Munsie Enterprises Inc - CCC 056809 (Steven Munsie)

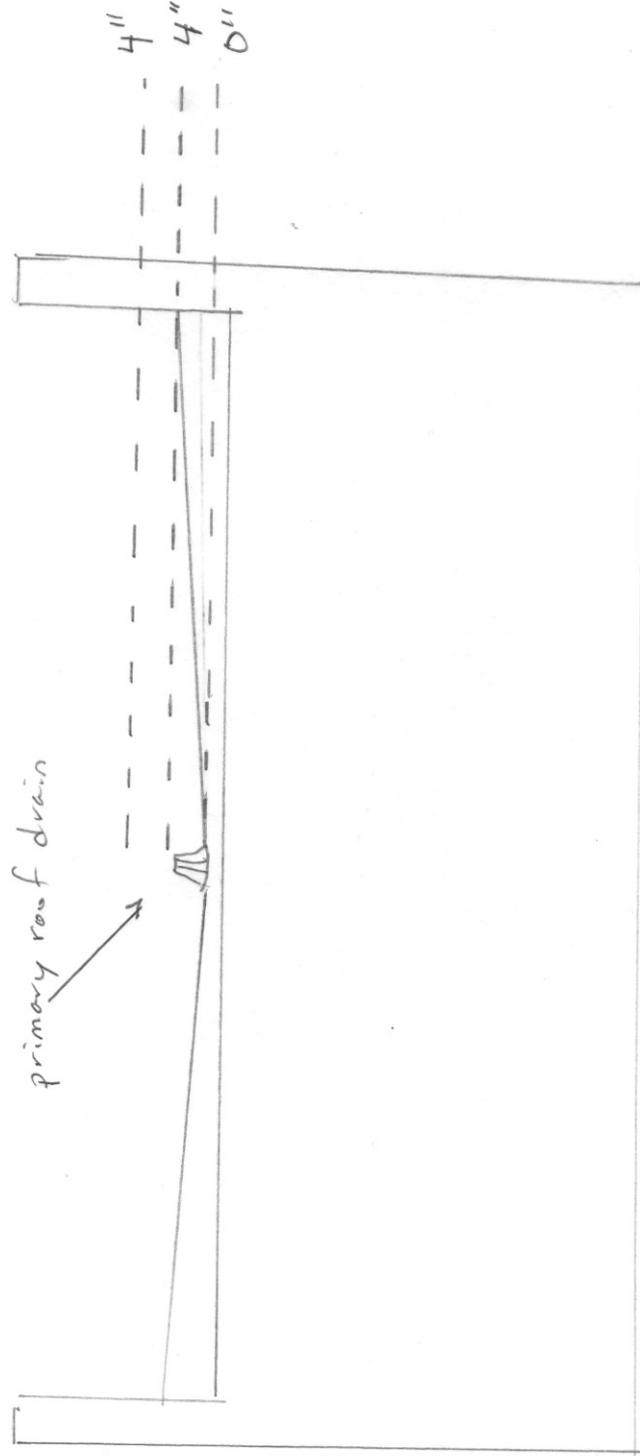
- Mounting the overflow scupper flush with the deck height by parapet on this illustration would be 4" above primary drain system
- Mounting "2"-4" above the roof deck" as per FBC 1503.4.21 would allow 2"-4" more rain water to accumulate before overflow scuppers would be useful.
